**BOARD OF ZONING ADJUSTMENT
STAFF REPORT**

6250

Eco-Site II, LLC

431 Azalea Road
(East side of Azalea Road, 340'± South of Bourgeois Drive).

SITE PLAN

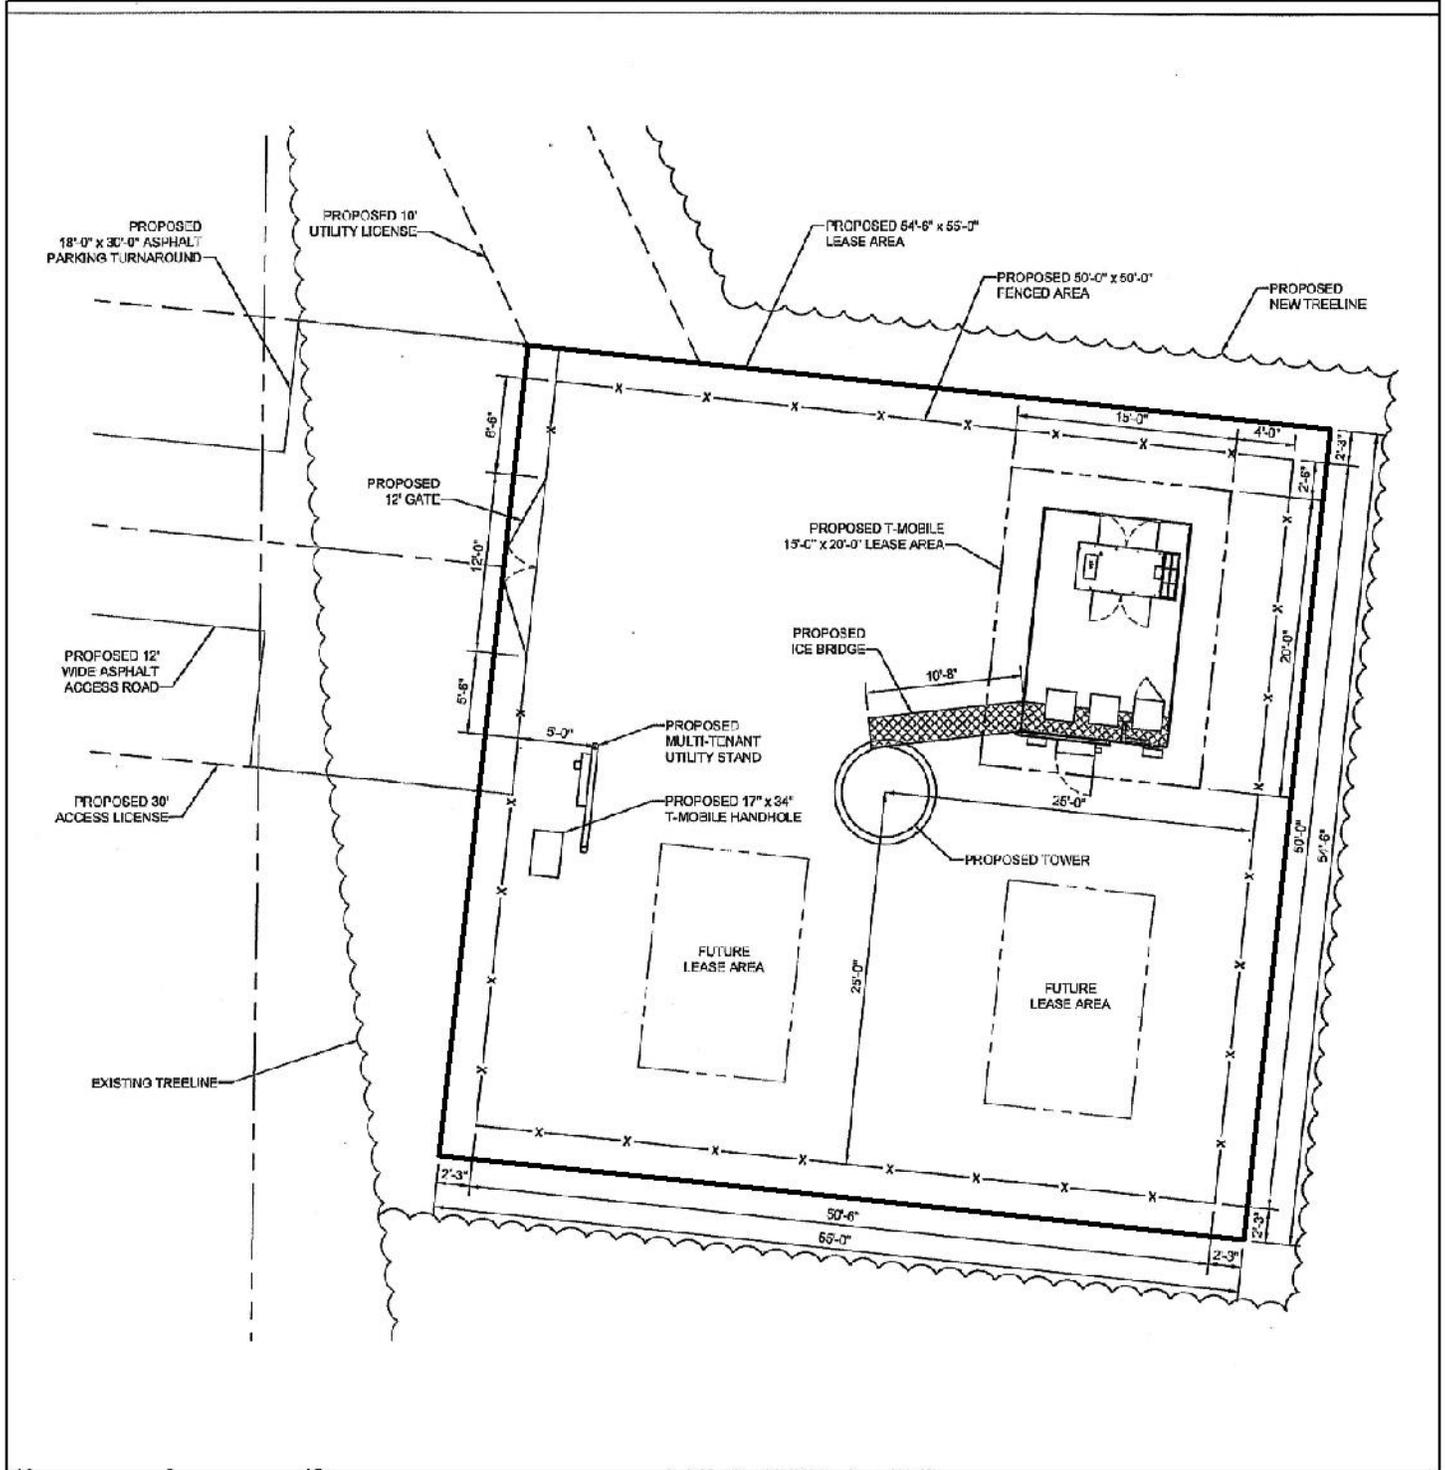
It should also be noted that there is a discrepancy in the boundary dimensions and site configuration between the Planning Approval site plan and the one-lot Subdivision preliminary plat. The site plan indicates an area along Azalea Road as being a part of the site but which was dedicated to the City for public right-of-way in 1970 as a condition of the 1969 rezoning of the site to its current B-1 classification. This discrepancy also appears on the site plan submitted for the application at hand. However, as the discrepancy can be corrected on a revised site plan should the Variance requests be approved, staff does not see a need for a holdover on the review of the Variance requests.

It should be mentioned that the site plan indicates compliance with the requirement for paved access and parking for the tower compound. No barbed wire fencing is indicated on the site plan, and it should be noted that barbed wire fencing is not allowed in B-1 districts. Therefore, a note should be added to a revised site plan stating that no barbed wire fencing may be utilized on the site.

With regard to the previously-mentioned site plan discrepancy, the site plan should be revised to remove the line labeled as "APPARENT RIGHT OF WAY LINE" and indicate the current right-of-way line along the East side of the area labeled as "RIGHT OF WAY FOR PUBLIC STREET AND SERVICE ROAD PURPOSES INSTRUMENT #179870 BOOK 961 PAGE 683". Since that area is actually City property, it should not be included within the property boundary.

- 3) revision of the site plan to provide compliant tree and landscaping, to be coordinated with the Planning and Zoning Department;
- 4) placement of a note on a revised site plan stating that no barbed wire or similar fencing is allowed on the site;

- 5) revision of the site plan to remove the line labeled as "APPARENT RIGHT OF WAY LINE" and indicate the current right-of-way line along the East side of the area labeled as "RIGHT OF WAY FOR PUBLIC STREET AND SERVICE ROAD PURPOSES INSTRUMENT #179870 BOOK 961 PAGE 683";

1
C5
MONOPOLE TOWER ELEVATION
 NOT TO SCALE

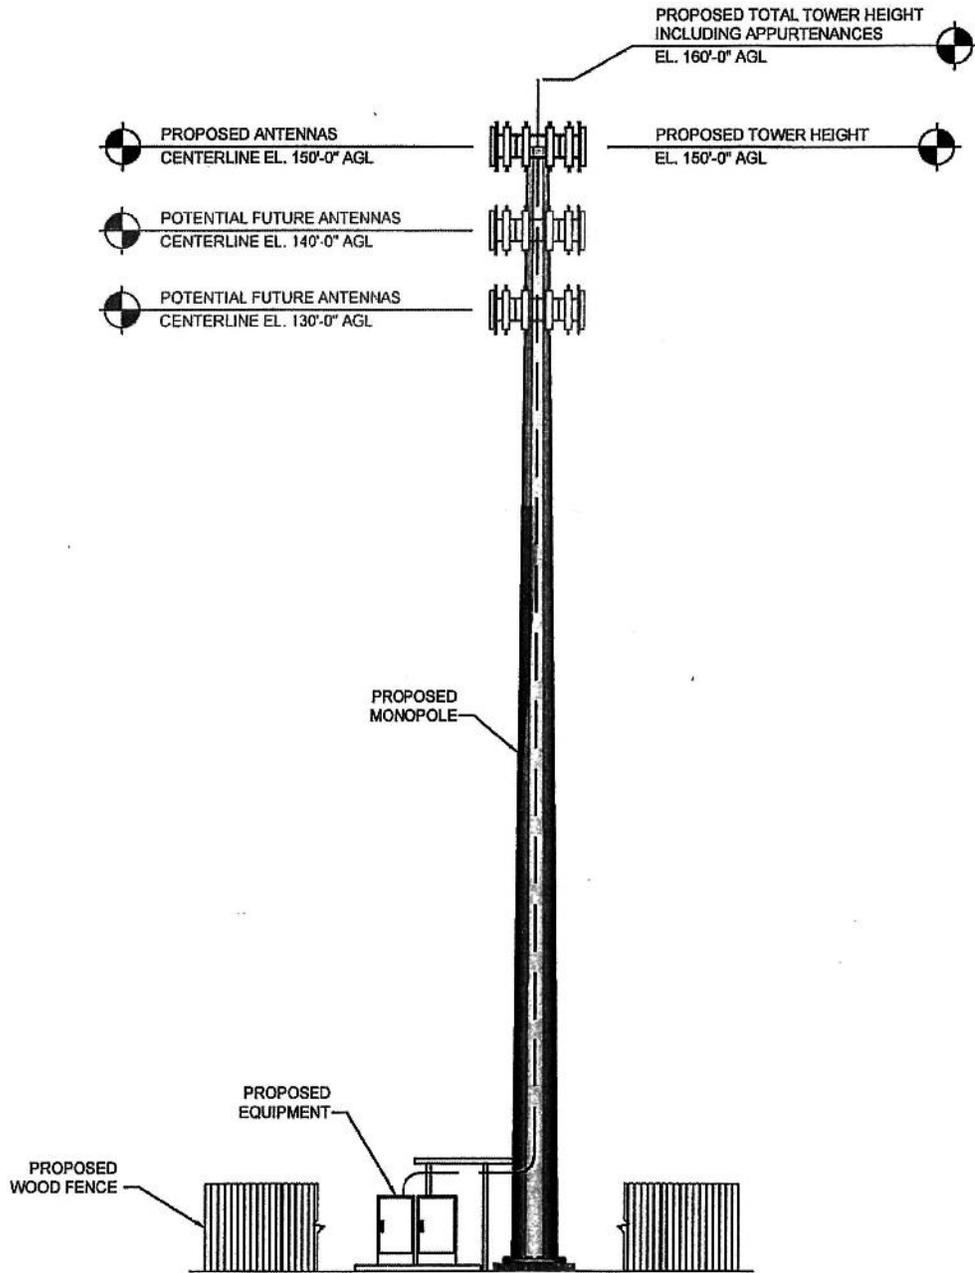
Specific to the Height Variance request, the applicant states that the 150' height is required for the proposed use. In light of the technical data submitted, and the illustration of a hardship imposed by the lack of existing towers within the area on which to collocate, the Height Variance request would seem reasonable.

- 1) the tower is limited to a monopole design with an over-all structure height of 150', including antennae, with a 10' lighting rod atop;
- 2) subject to the approval of the Planning Approval and Subdivision applications for the proposed tower and site;
